## Eastern Corridor Segments II and III

Combined Linwood/Eastern Interchange and US 50/Red Bank Interchange Focus Area

# US 50/RED BANK CONNECTIVITY

**Figure X-4D**  
**EXTEND WOOSTER TO TIE  
DIRECTLY INTO RED BANK ROAD**

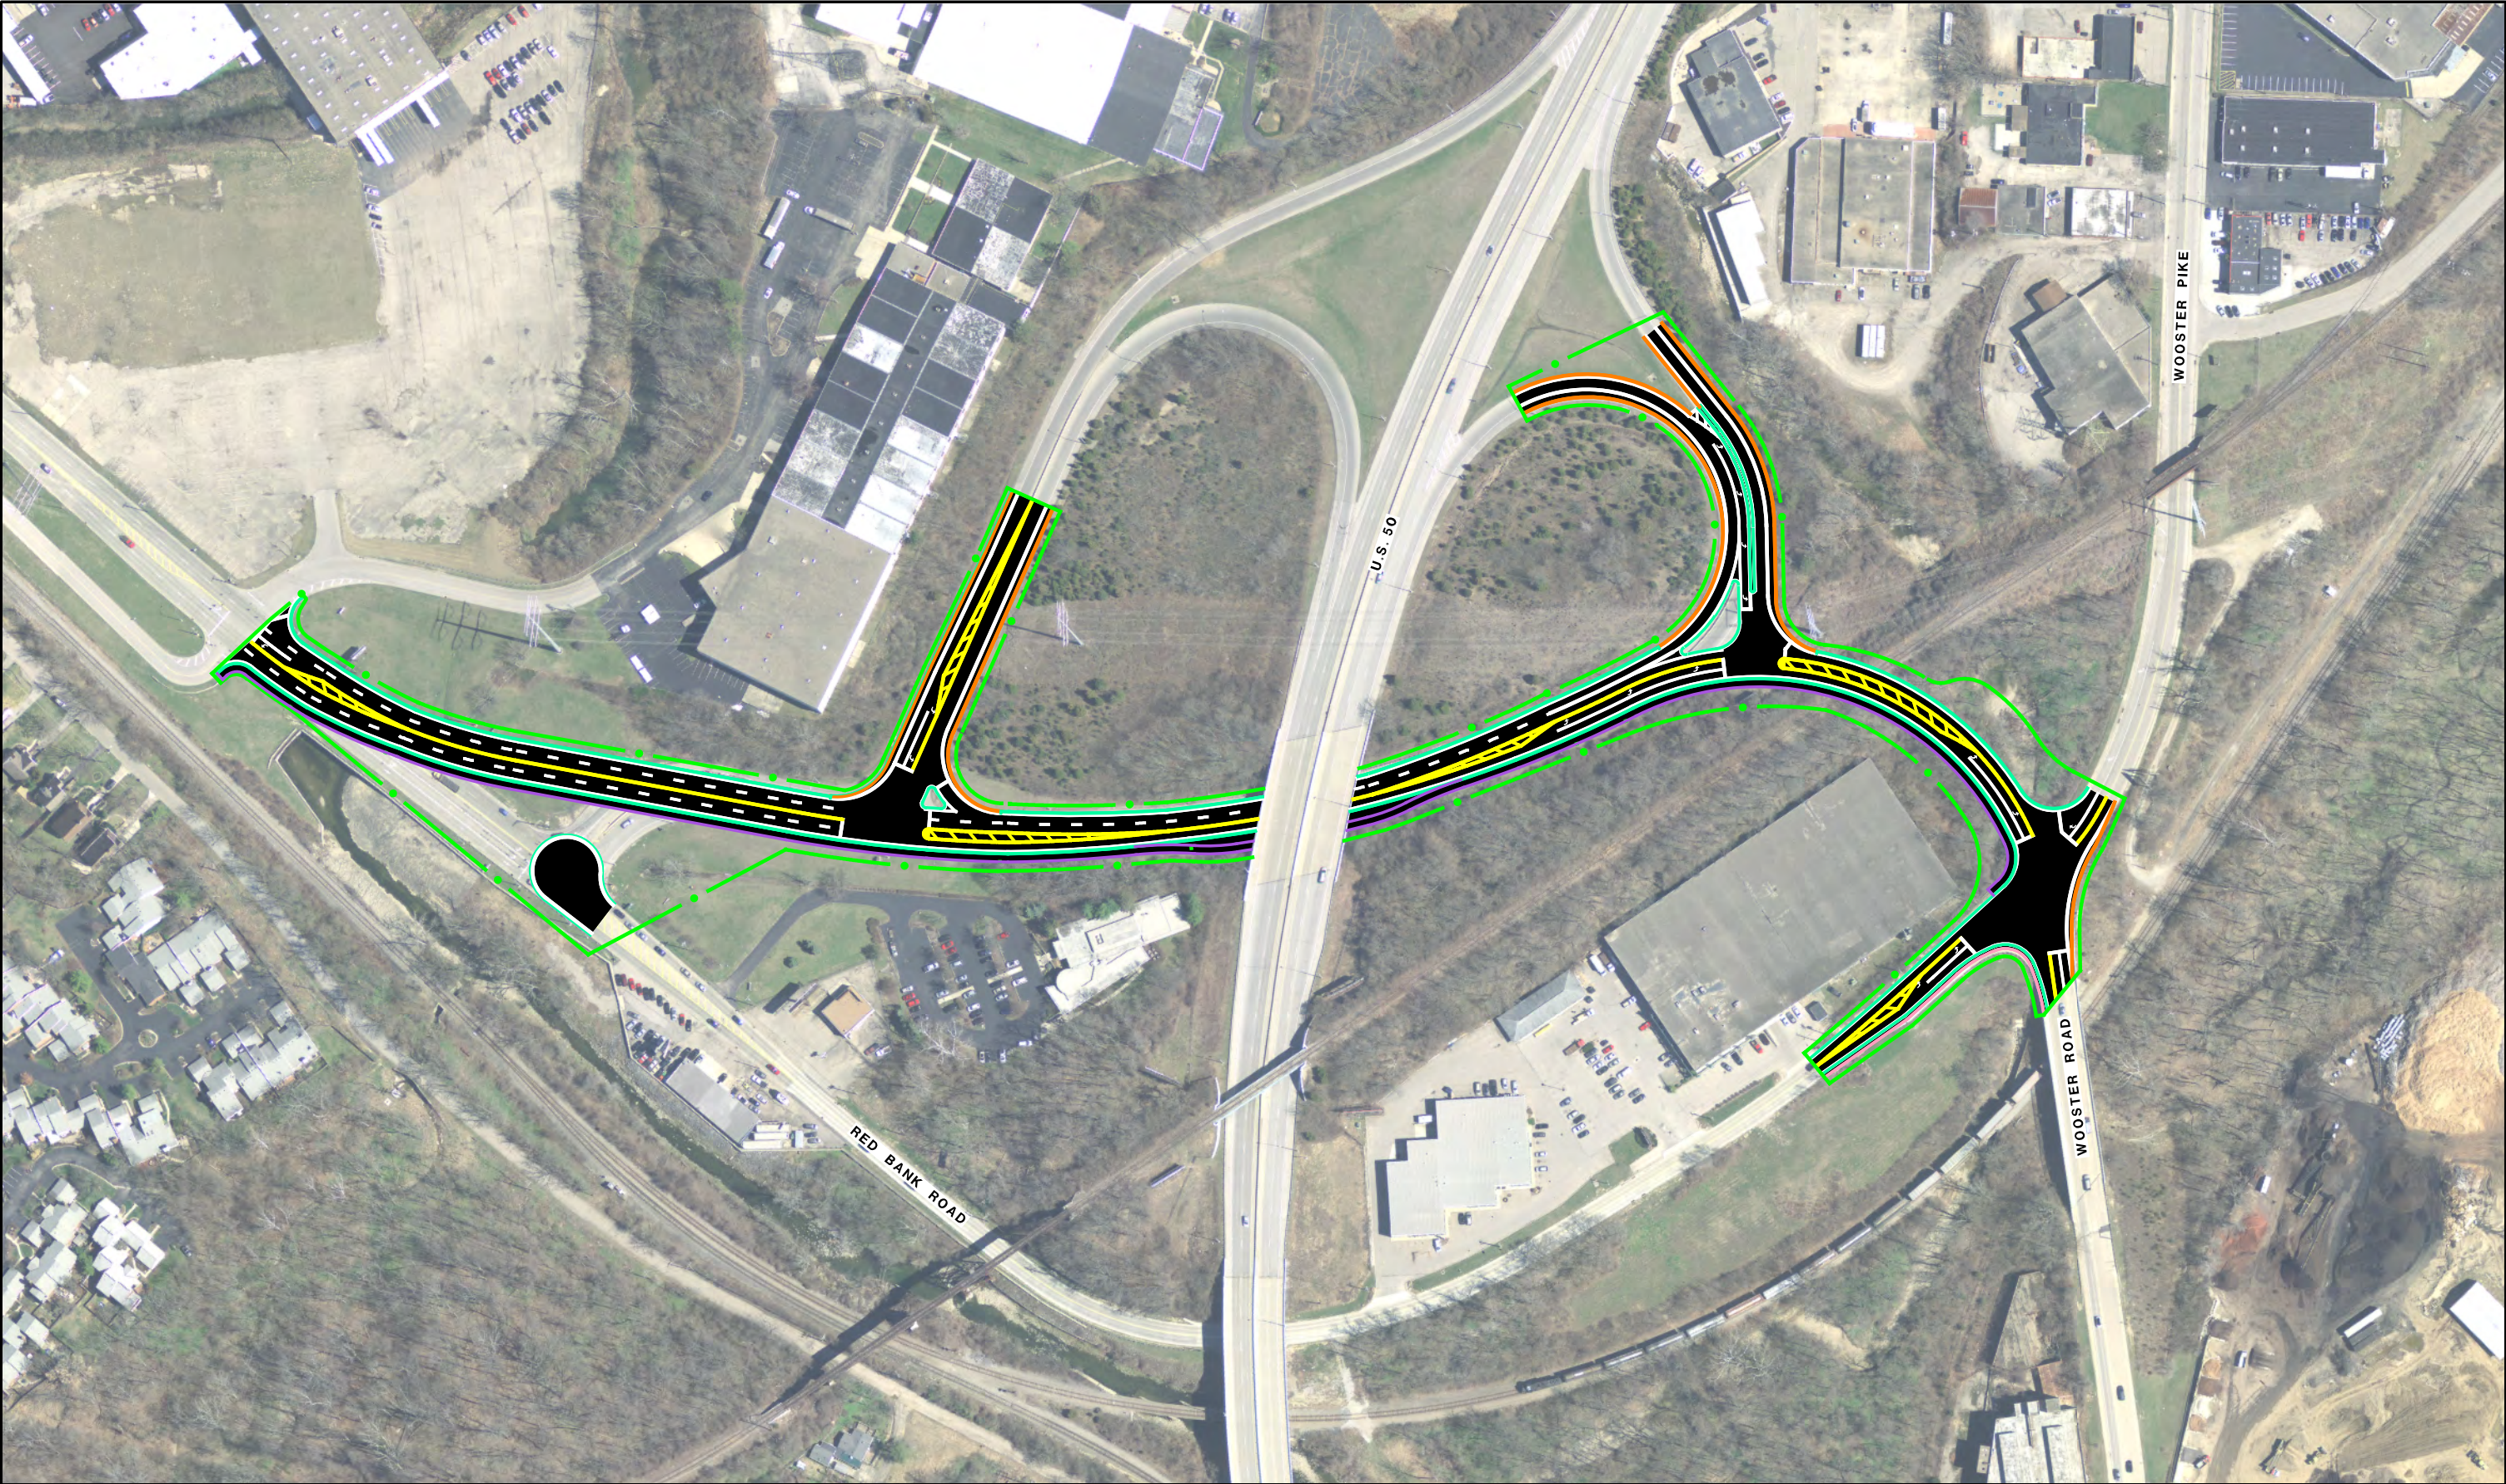
- (Comments are presented as submitted by Committee members; no edits to content were made.)
- Mariemont does not support creating a cul-de-sac on Red Bank and eliminating the current intersection of Colbank and Redbank. Multiple traffic routes currently provide options for vehicle and truck traffic from businesses.

- This concept is very similar to X-4d-1. X-4d includes signals at all three intersections; X-4d-1 has a signal at one intersection, is stop-controlled at another and has a roundabout at the third. Both concepts work well.

- Mariemont expressed concern about making the current Red Bank/Colbank intersection a cul-de-sac. Redundancy is desired to provide two routes for trucks to Red Bank Road.

- When considering the existing roadway configuration along Red Bank, it is virtually impossible to create a shared-use path from Red Bank to Armleder and the Little Miami Trail due to existing structural constraints (lack of space, guardrails, retaining walls). This concept however, includes an option to construct a shared-use path along the south side of Colbank and its new connection to Wooster Road.

- No further study. Concept X-4d-1 (roundabout at Wooster intersection) appears to be a better option and allows for a better shared-use path connection (the roundabout allows a shared-use path to utilize existing width on the bridge).

**Figure X-4D-1**  
**EXTEND WOOSTER TO TIE  
DIRECTLY INTO RED BANK ROAD**

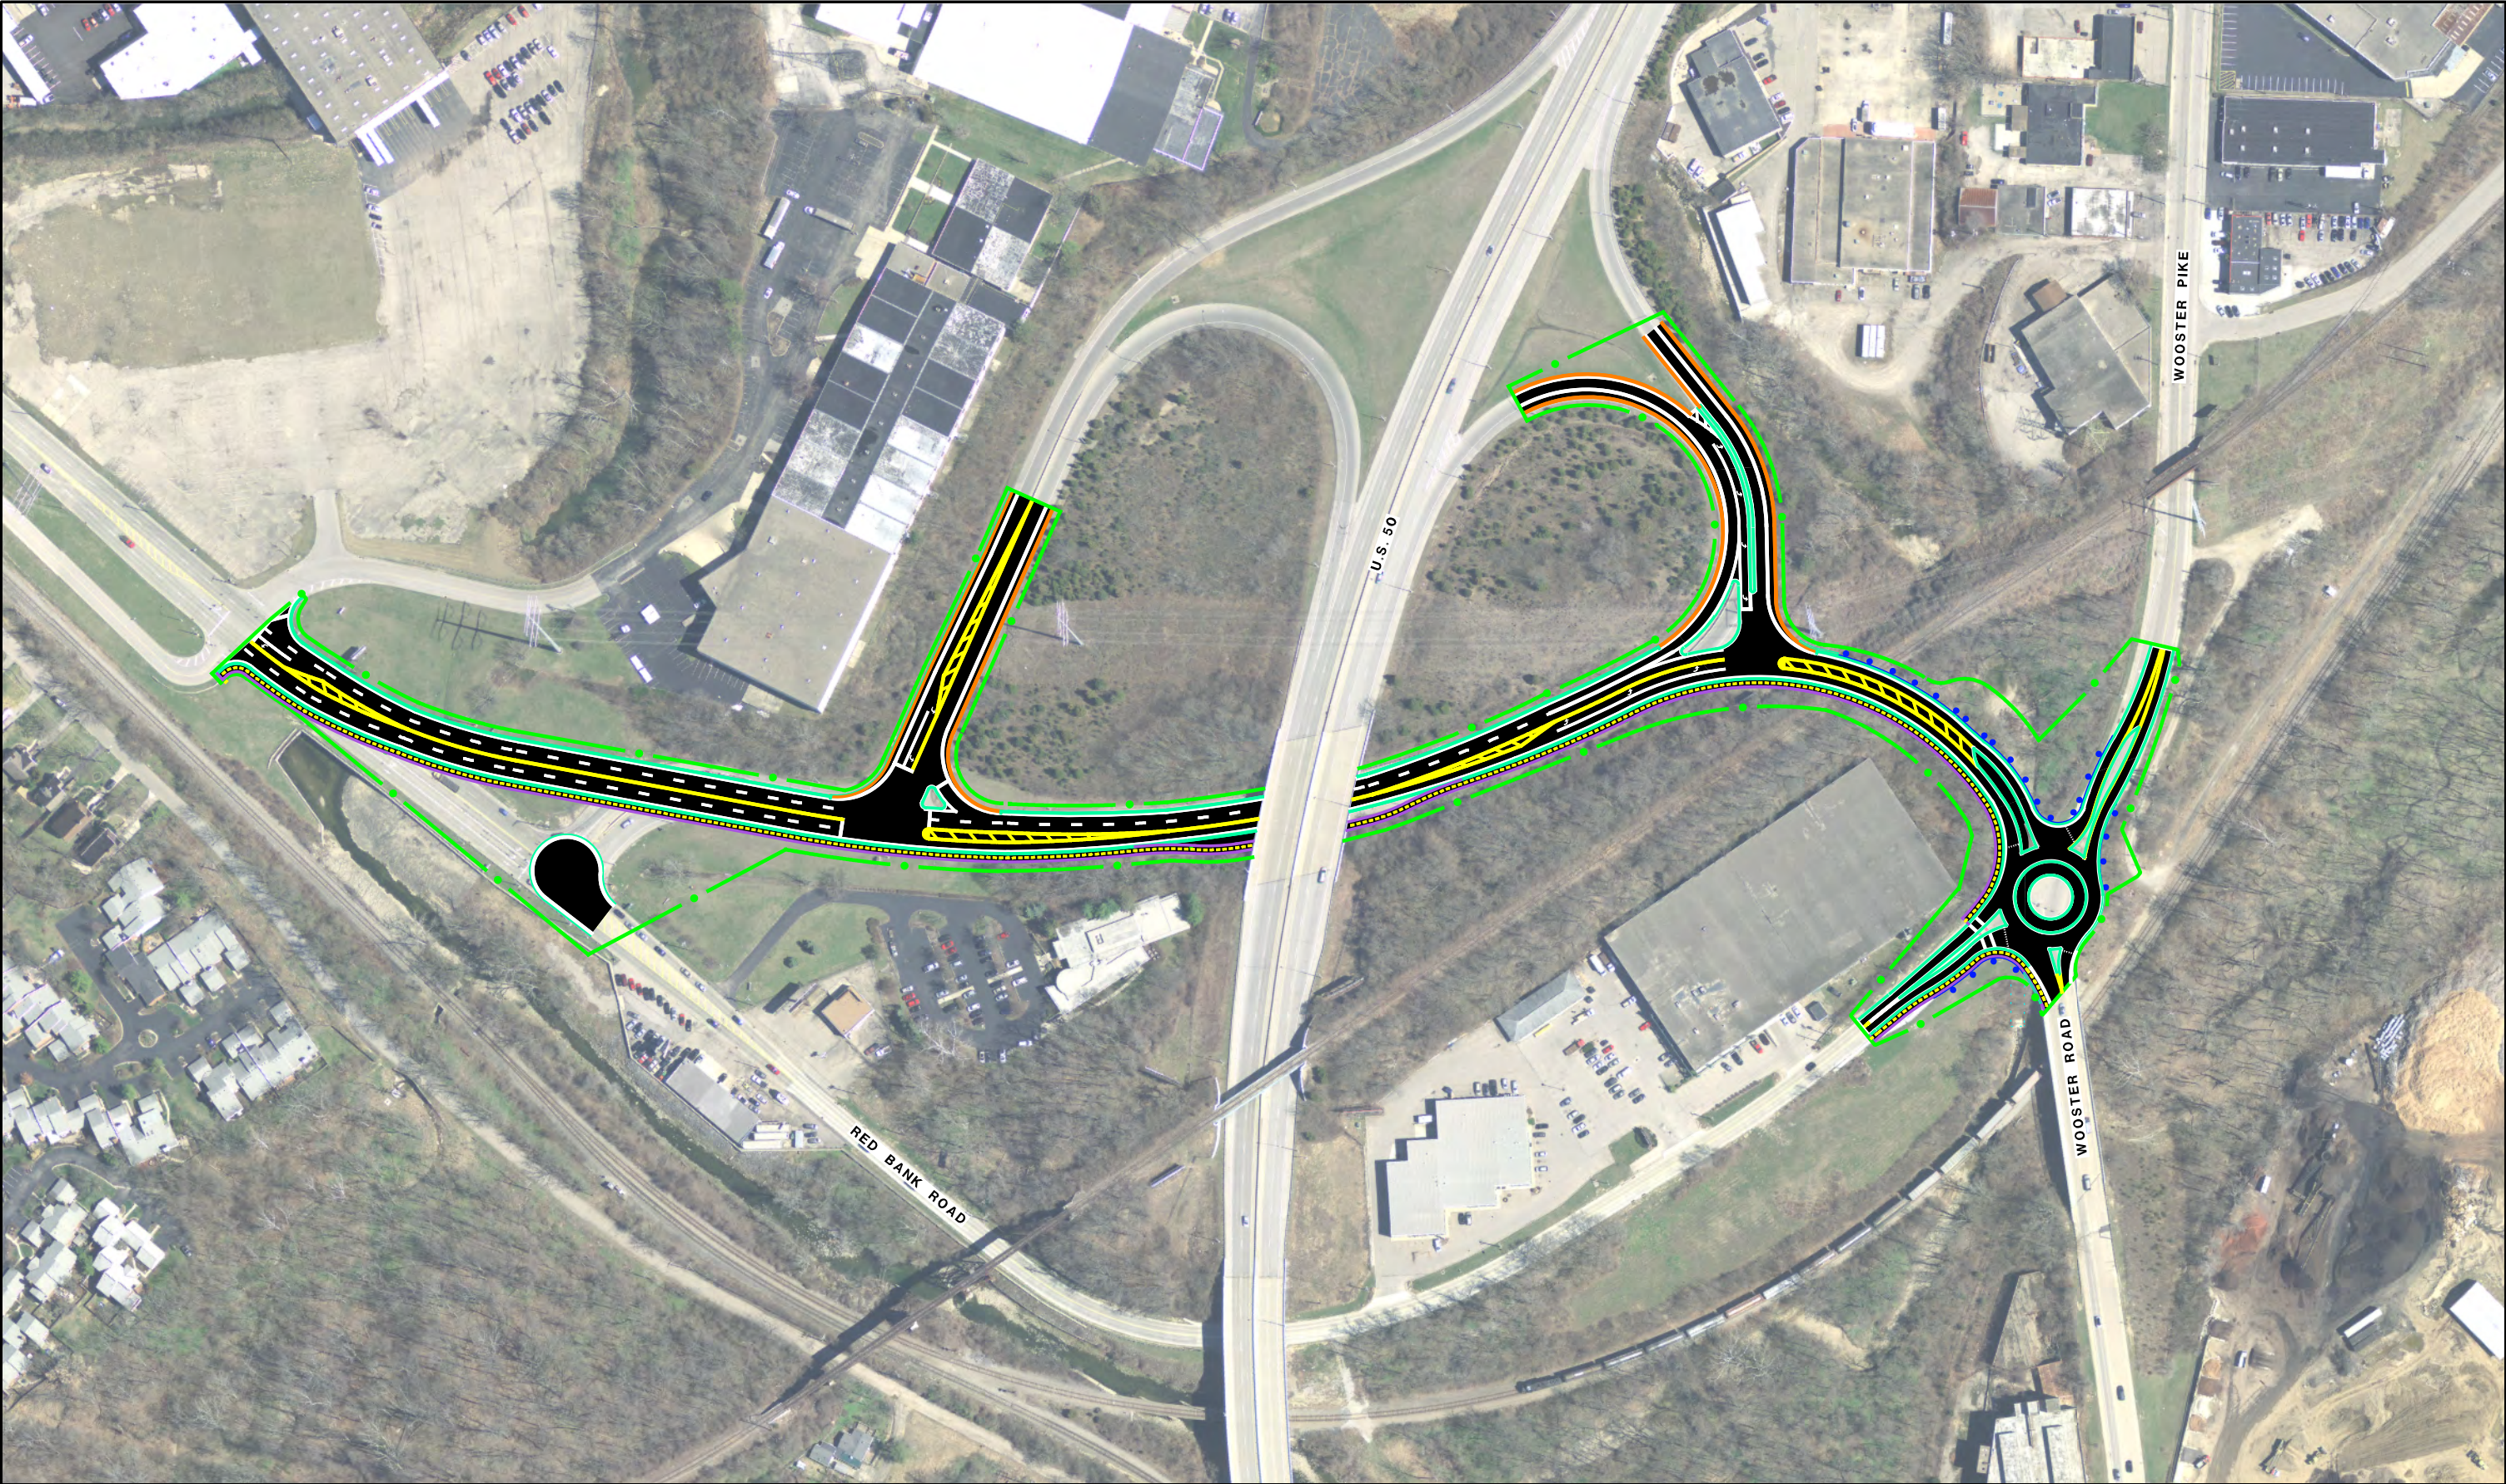
- The roundabout portion of this concept provides an advantage over the signalized intersection by providing a continuous flow connection from Wooster Road to Red Bank Road. It also eliminates the need for the existing left turn lane on the Wooster bridge, allowing space for a shared-use path without widening the bridge.

- This concept includes an option to construct a shared-use path along the south side of Colbank and its new connection to Wooster Road. The grade of the new roadway is flat.

- The concept does not preclude future rail use in the area, but would require building a new bridge. The cost of constructing a new bridge has

- not been estimated.
- The roundabout is designed for full semi-truck utilization.
- No additional comments received following the 9/7 meeting.

- A benefit of this concept is that it opens up a new bicycle/pedestrian corridor option.
- The committee agreed to no longer pursue this roadway concept.
- The committee also agreed that the roundabout at Wooster Road and the addition of the shared-use path in this alignment should be advanced as other projects [I-20b (E4) & BIKE-4a (E7)].

- No further study.
